Re: Florida Power & Light Company  
Proposed Turkey Point Units 6 and 7  
Docket Nos. 52-040 and 52-041  
Response to NRC Request for Additional Information Letter 120329  
(eRAI 6354 Rev. 0) Related to ESRP Section 2.3.1 - Hydrology

Attachment 1: FPL Response to NRC RAI EIS 2.3.1-2 (eRAI 6354 Rev. 0)

Attachment 2: FPL Response to NRC RAI EIS 2.3.1-6 (eRAI 6354 Rev. 0)

**Figure 1**  
**Extended Power Uprate Monitoring Well Locations**

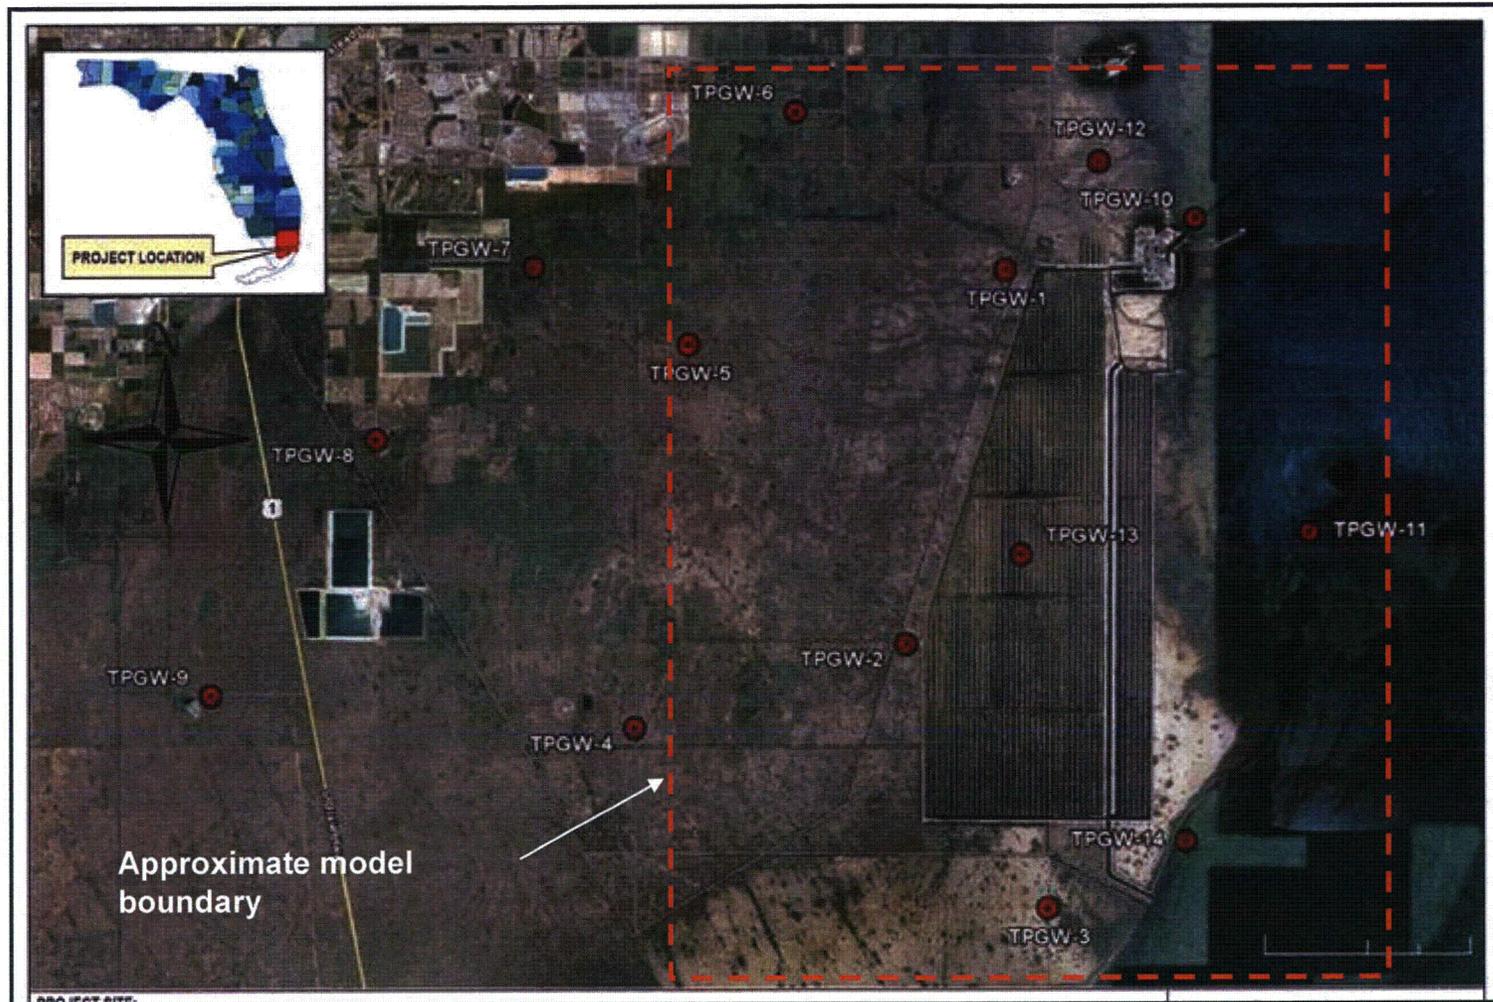
Sampling errors result from the inadequate density, frequency, and duration of measurements used to characterize the environment. The density, frequency, and duration of measurements have been provided either indirectly or directly in the applicant's environmental report and security control assessor information. However, the applicant has not discussed the basis for their implicit assumption that potential sampling errors are not a plausible basis that might change the impact determination. The review team requests that the applicant discuss the basis for this assumption.

The EPU borings, as shown in Figure 1 and designated as TPGW wells (JLA Geosciences, Inc., 2010), were utilized for comparison with the model hydrostratigraphy. Stratigraphic data

from these wells improved the offsite subsurface dataset and were used in the Turkey Point Units 6 & 7 groundwater flow model to qualitatively assess the thickness and extent of layers used in the model. Specifically, the thickness and extent of the Upper and Lower Higher Flow Zones were identified in these borings and compared to the conceptual model hydrostratigraphy, which was already incorporated into the model. The results of this comparison showed agreement between the conceptual model and the newer boring information. This comparison suggests that the boring density used in the conceptual model was sufficient to adequately characterize the subsurface conditions.

**Figure 1. General-Head Boundaries along Model Perimeter**

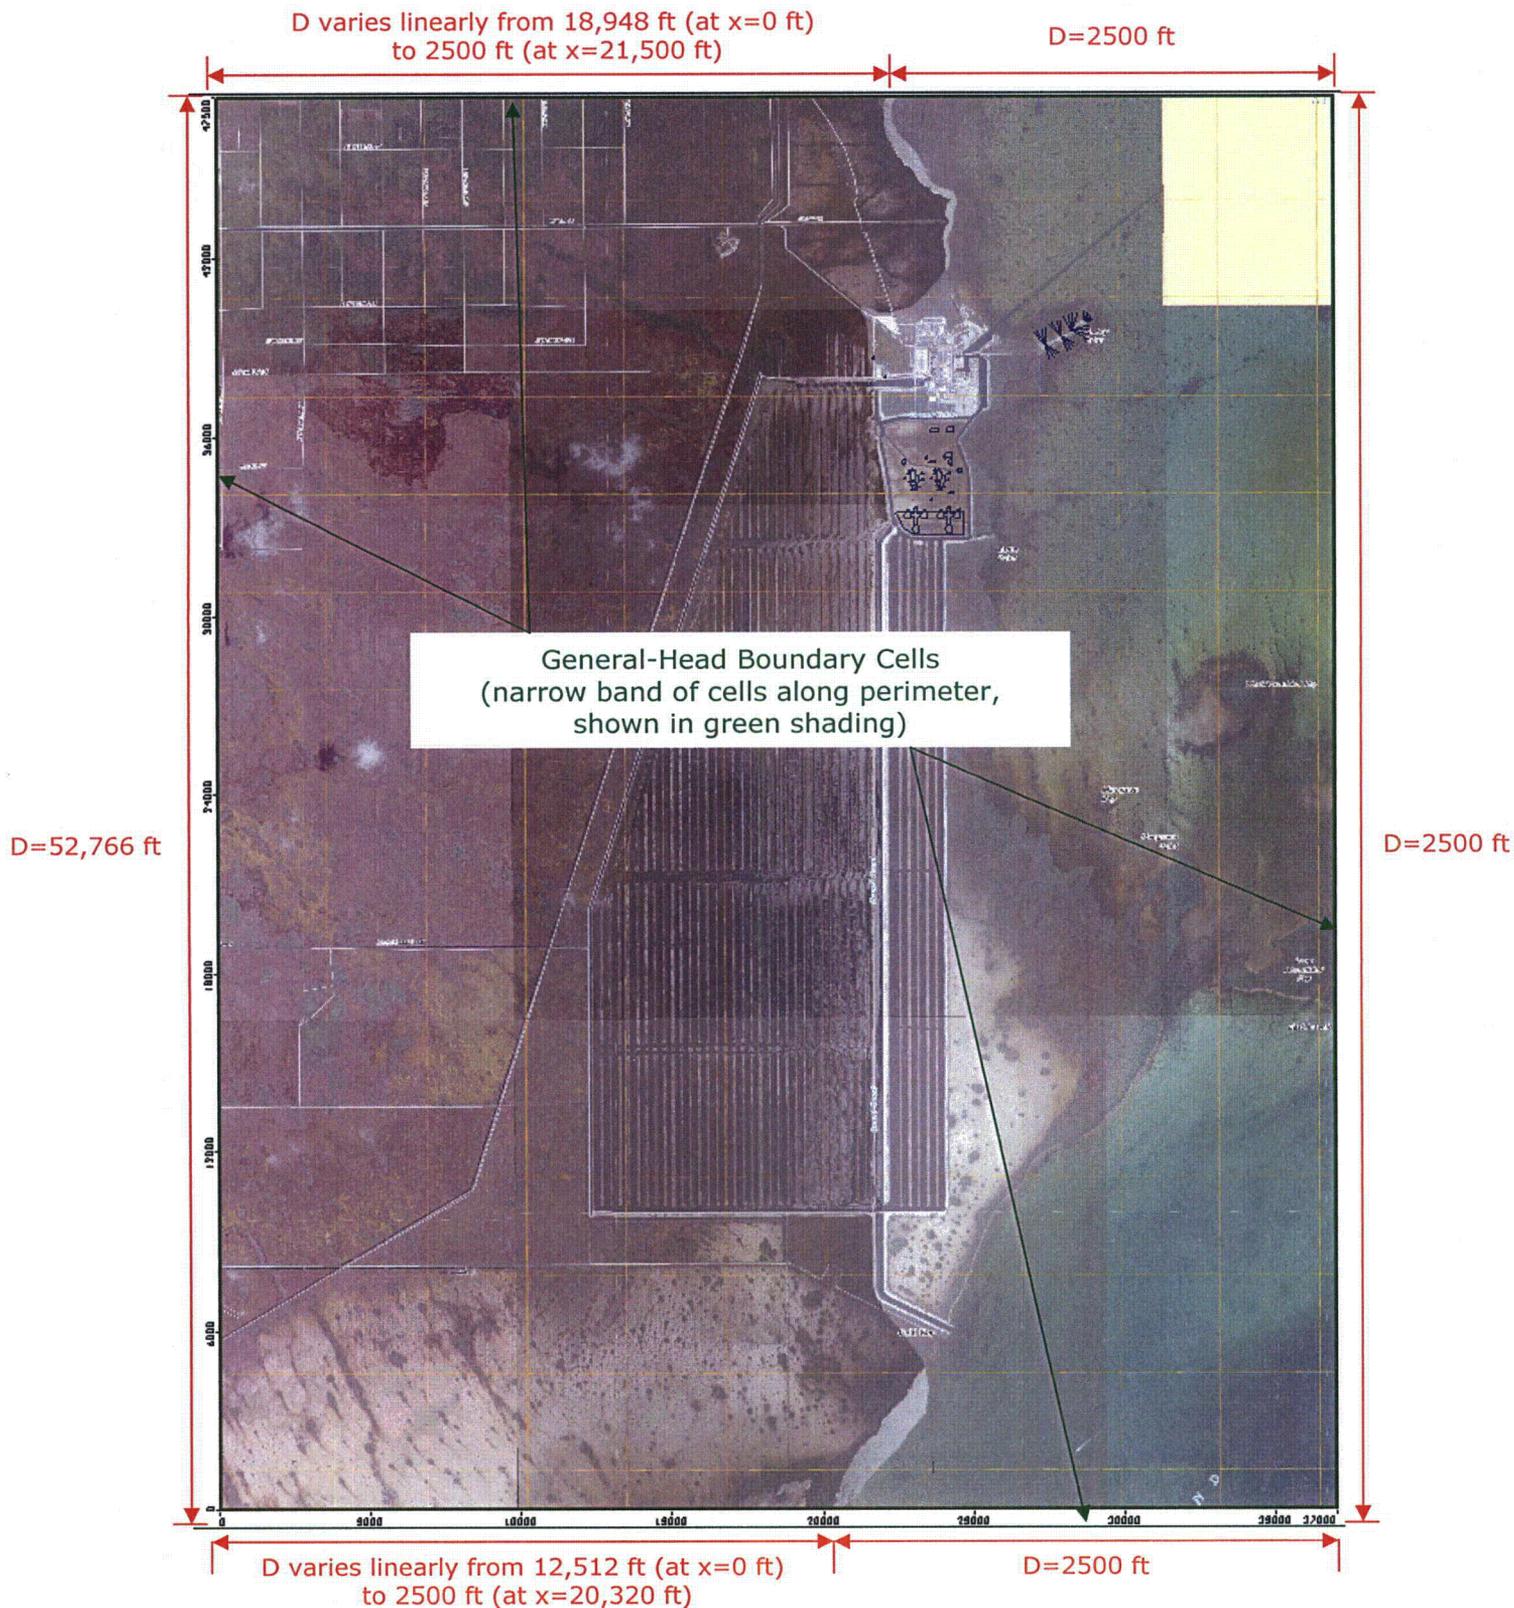
- a. the perimeter boundaries defined as "general head boundaries"
- b. the "river package" boundary between Plant Discharge Canal and the Upper High Flow Zone (Model Layer 4)
- c. the "river package" boundary representing the regional canals and the Interceptor Ditch
- d. the general head boundary at the bottom of Biscayne Bay for each of the materials defined at this boundary (i.e., sandy sediment and rock)

Model perimeter boundaries are shown in Figure 1. The cell width along the model perimeter is small relative to the model area, so the boundary cells appear as a narrow green-shaded band in Figure 1 around the model perimeter. The general-head boundary (GHB) package was used to simulate groundwater flow into and out of all sides of the model domain and for all model layers. The rationale for using this boundary package is that with the exception of Biscayne Bay, no water bodies representing fixed-water elevations exist. The benefit of using the GHB package for perimeter boundaries is that it permits extending boundary conditions outside of the numerical grid rather than expanding the numerical grid to coincide with natural boundaries.

The perimeter boundary distances (D) are assigned as follows (see Figure 1):

- Western boundary:  $D = 52,766$  ft (western extent of available water level data)
- Eastern boundary:  $D = 2500$  ft (along Biscayne Bay)
- Northern boundary: The Biscayne Bay coastline along this boundary is located at model grid x-coordinate of 21,500 ft. For cells inland of Biscayne Bay,  $D = 18,948 \text{ ft} - X_i \times [(18,948 \text{ ft} - 2500 \text{ ft}) / 21,500 \text{ ft}]$ , where  $X_i$  is cell center coordinate in x-direction. For Biscayne Bay cells,  $D = 2500$  ft.
- Southern boundary: The Biscayne Bay coastline along this boundary is located at model grid x-coordinate of 20,320 ft. For cells inland of Biscayne Bay,  $D = 12,512 \text{ ft} - X_i \times [(12,512 \text{ ft} - 2500 \text{ ft}) / 20,320 \text{ ft}]$ , where  $X_i$  is cell center coordinate in x-direction. For Biscayne Bay cells,  $D = 2500$  ft.

As an example, the northern perimeter boundary cell in Model Layer 5 at Row 1 and Column 182 is in the Upper Higher Flow Zone, with x-coordinate for the cell center at 18,023 ft. The boundary distance is determined by linear interpolation:

$$D = 18,948 \text{ ft} - 18,023 \text{ ft} \times [(18,948 \text{ ft} - 2500 \text{ ft}) / 21,500 \text{ ft}] = 5160 \text{ ft}$$

$$\begin{aligned} C &= (L \times W) \times K_h / D \\ &= [(100 \text{ ft} \times 1 \text{ ft}) \times 29.6712 \text{ cm/s} \times (2835 \text{ ft/day} / 1 \text{ cm/s})] / 5160 \text{ ft} \\ &= 1630 \text{ ft}^2/\text{day} \end{aligned}$$
